# IEEE P802.3az D1.0 Clause 55 State Diagrams *Updated*

Rick Tidstrom, Broadcom

IEEE P802.3az Task Force

Dallas, November 2008

# PCS 64B/65B Transmit State Diagram

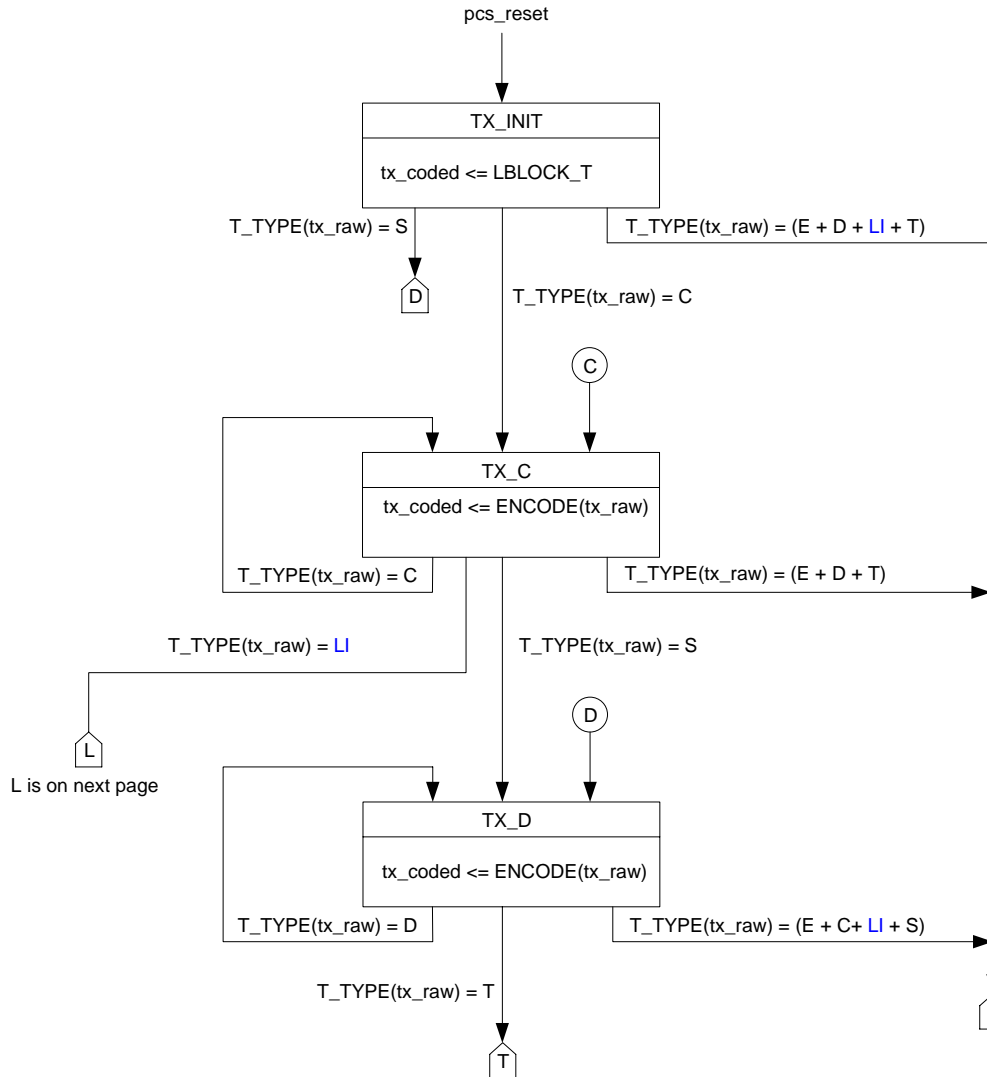
- New states to be added to support Low Power Idle:
  - TX\_L (Transmit Low Power Idle)
  - TX\_WN (Transmit Wake Normal)
  - TX\_WE (Transmit Wake Error)
- New transitions to be added to support Low Power Idle:
  - T\_TYPE(tx\_raw) = LI causes transition from TX\_C to TX\_L
  - T\_TYPE(tx\_raw) = LI causes transition from TX\_INIT to TX\_E
  - T\_TYPE(tx\_raw) = LI causes transition from TX\_D to TX\_E
  - T\_TYPE(tx\_raw) = LI causes transition from TX\_T to TX\_E
  - T\_TYPE(tx\_raw) = LI causes transition from TX\_E to TX\_E

# PCS 64B/65B Transmit State Diagram (2 of 3)

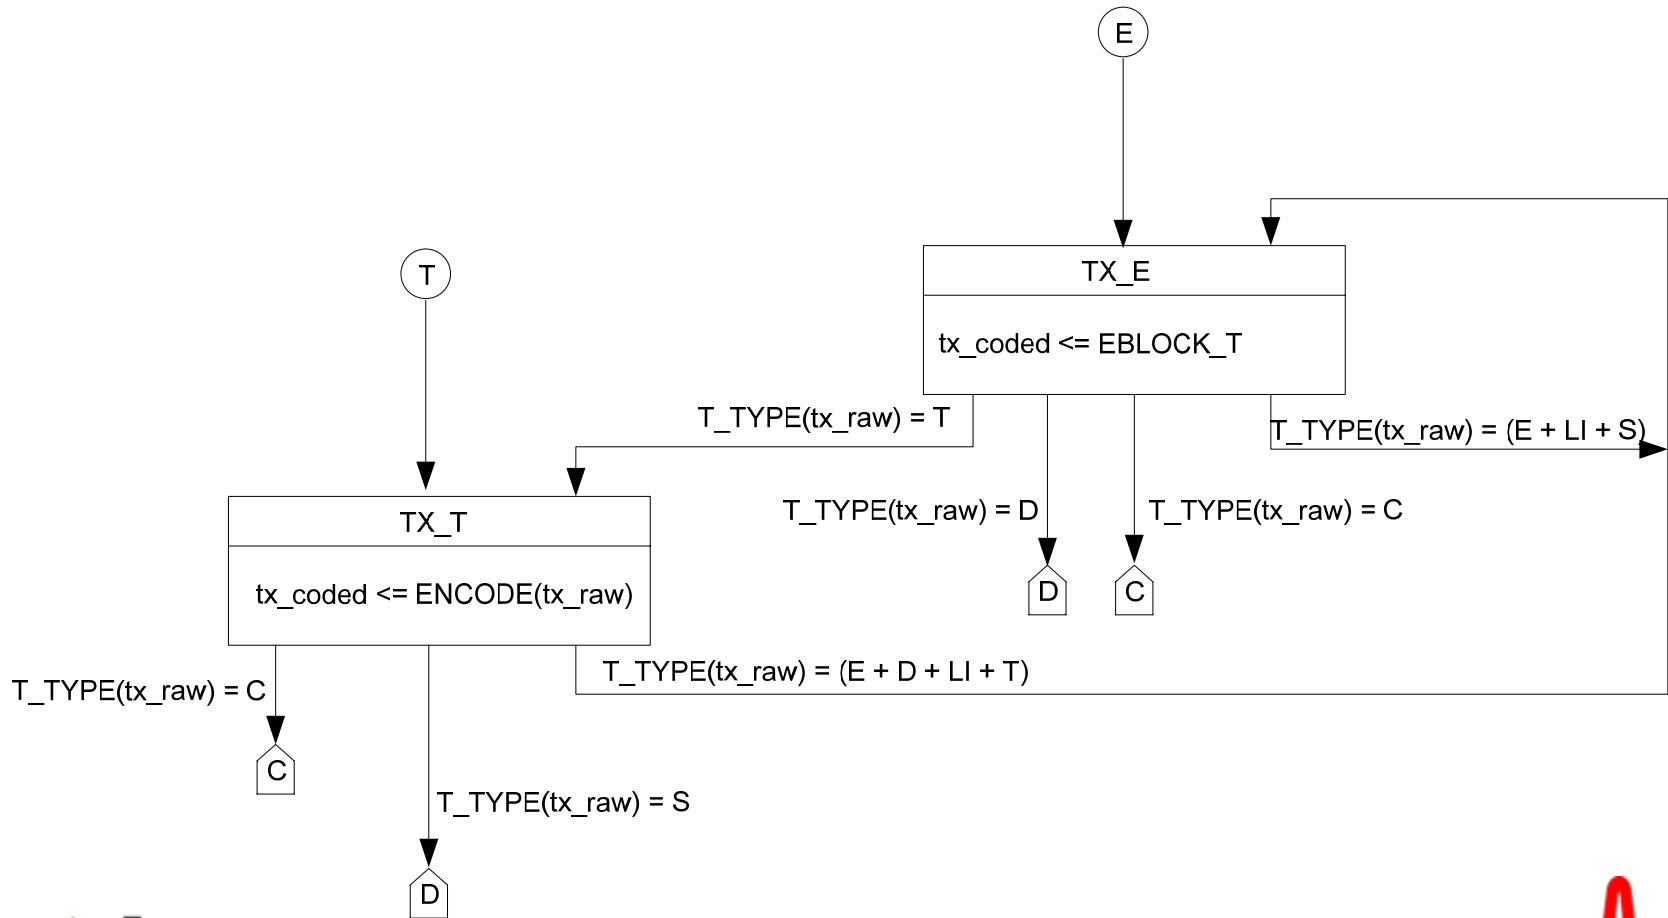
- New 64B/65B control codes to support Low Power Idle.
  - T\_TYPE(tx\_raw) = LI for Low Power Idle
  - T\_TYPE(tx\_raw) = I for Normal Idle
- In the following state diagrams, the transition variable “C” normally refers to any control code. However, when a state has an exit transition conditioned on C that is parallel to any other exit transition using “LI” or “I”, then C should be considered as any control code except for LI if it is used on any other exit transition from that state AND except for I if it is used on any other exit transition from that state.

# PCS LPI Transmit State Diagram

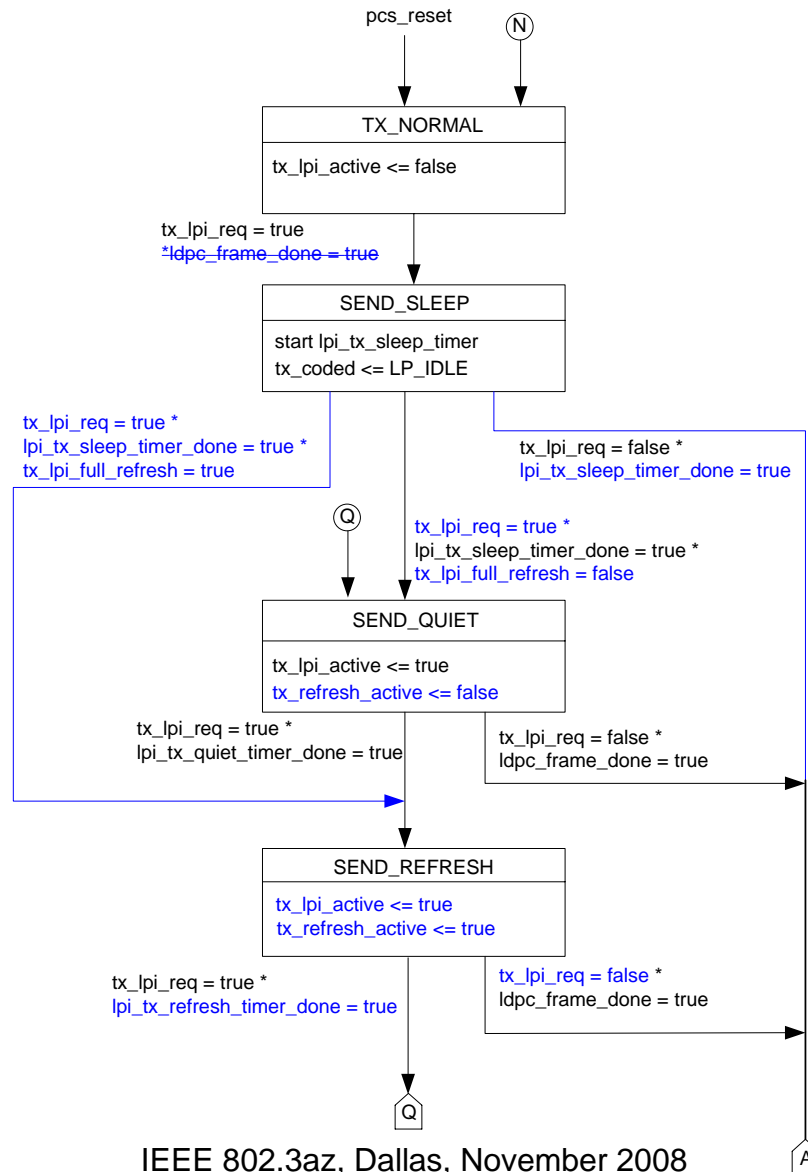
- Three new variables introduced (following parnaby\_01\_1108.pdf):
  - tx\_lpi\_full\_refresh (Transmit LPI Full Refresh)
    - Is set active when (lpi\_tx\_mode = QUIET) \* (lpi\_tx\_quiet\_timer\_done = true). It prevents partial refreshes from being transferred at the Sleep to LPI transition.
  - tx\_refresh\_active (Transmit Refresh Active)
    - 0 = Quiet
    - 1 = Refresh
  - tx\_alert\_active (Transmit Alert Active)

# PCS 64B/65B Receive State Diagram

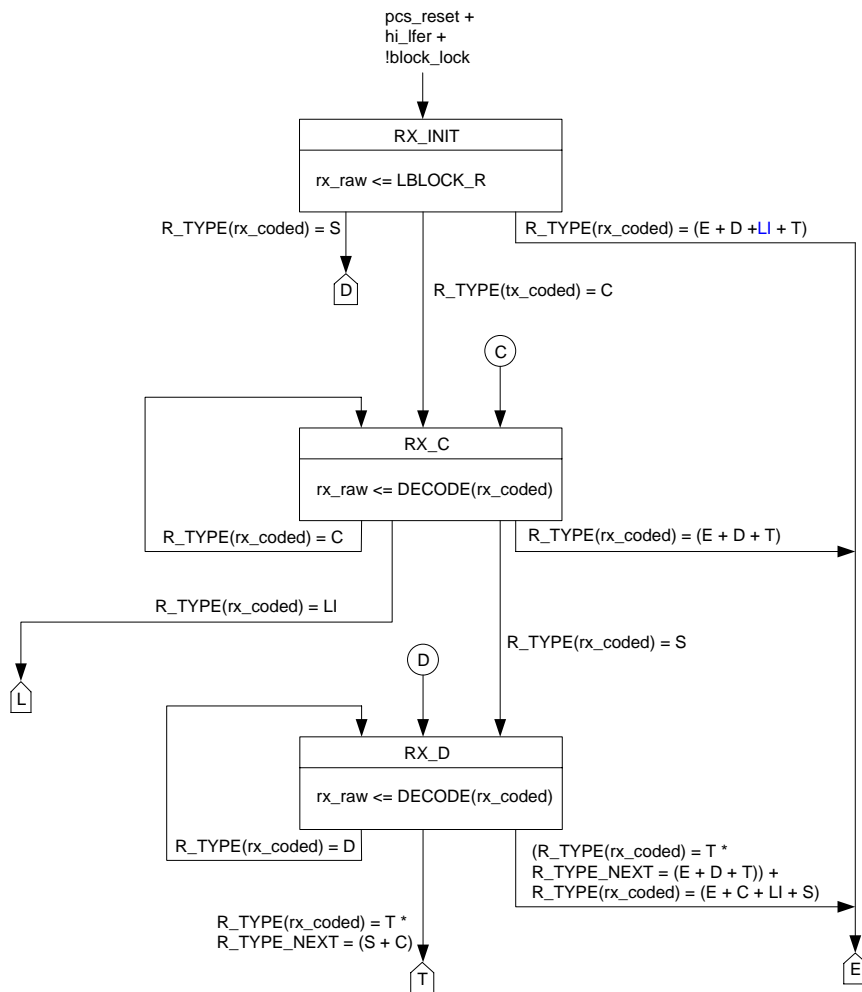
- New states to be added to support Low Power Idle:
  - RX\_L (Receive Low Power Idle)
  - RX\_W (Receive Wake)
- New transitions to be added to support Low Power Idle:
  - T\_TYPE(rx\_raw) = LI causes transition from RX\_C to RX\_L
  - T\_TYPE(rx\_raw) = LI causes transition from RX\_INIT to RX\_E
  - T\_TYPE(rx\_raw) = LI causes transition from RX\_D to RX\_E
  - T\_TYPE(rx\_raw) = LI causes transition from RX\_E to RX\_E

# PCS 64B/65B Receive State Diagram (2 of 2)

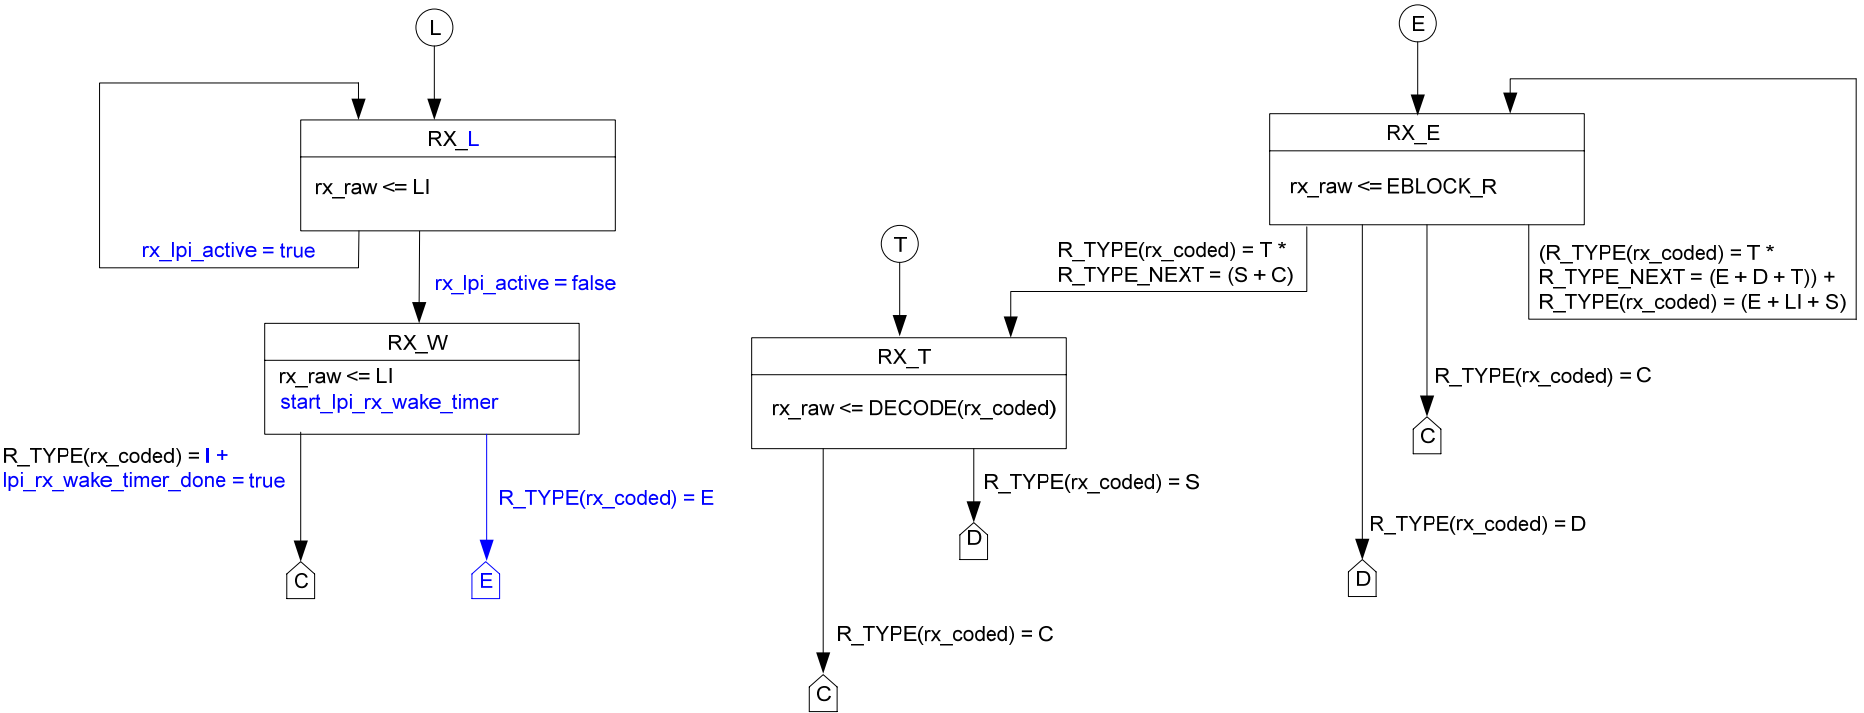
- One new variable introduced:
  - lpi\_rx\_wake\_timer – start value is equal to number of wake frames. Used to determine if link has exited successfully from Low Power Idle.
- Transitions from RX\_W
  - R\_TYPE(rx\_coded) = I indicates that the link is working, and the transmitter is in Wake Normal state.
  - R\_TYPE(rx\_coded) = E indicates that the link is working, and the transmitter is in Wake Error state.
  - lpi\_rx\_wake\_timer\_done indicates a that Wake has expired without seeing valid 65/64 blocks.

# PMA LPI Receive State Diagram (1 of 1)

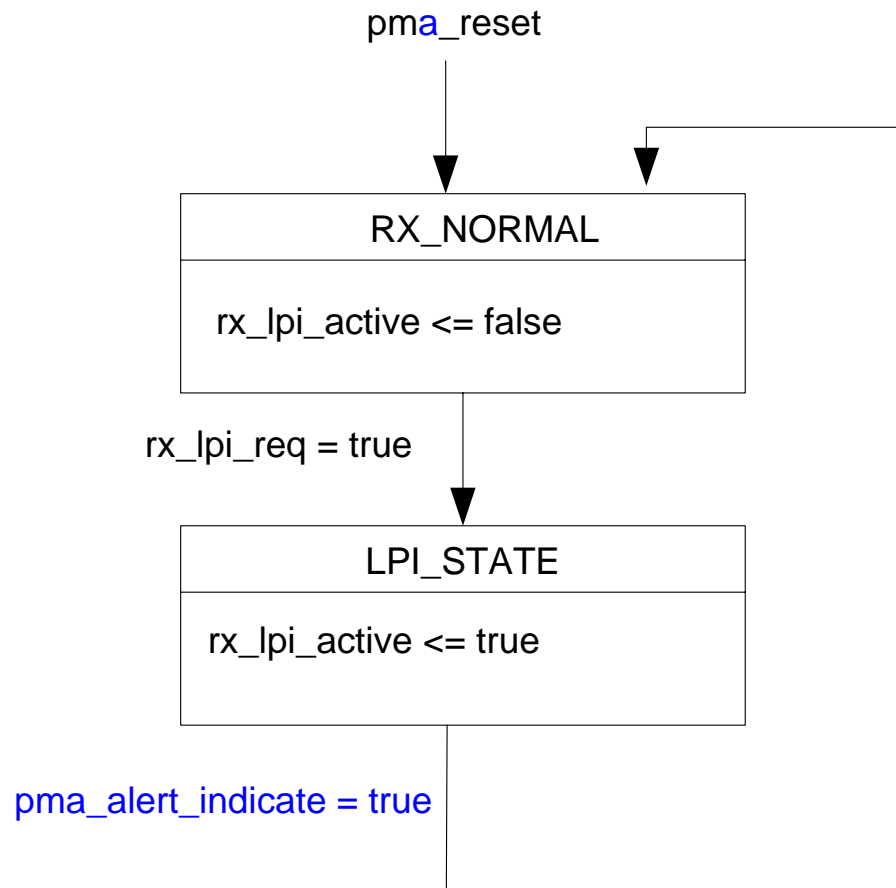
Note: State RX\_WAKE not needed.

After receiving alert, RX PMA can exit from QUIET/REFRESH cycling. PCS layer handles wake timers and processing.
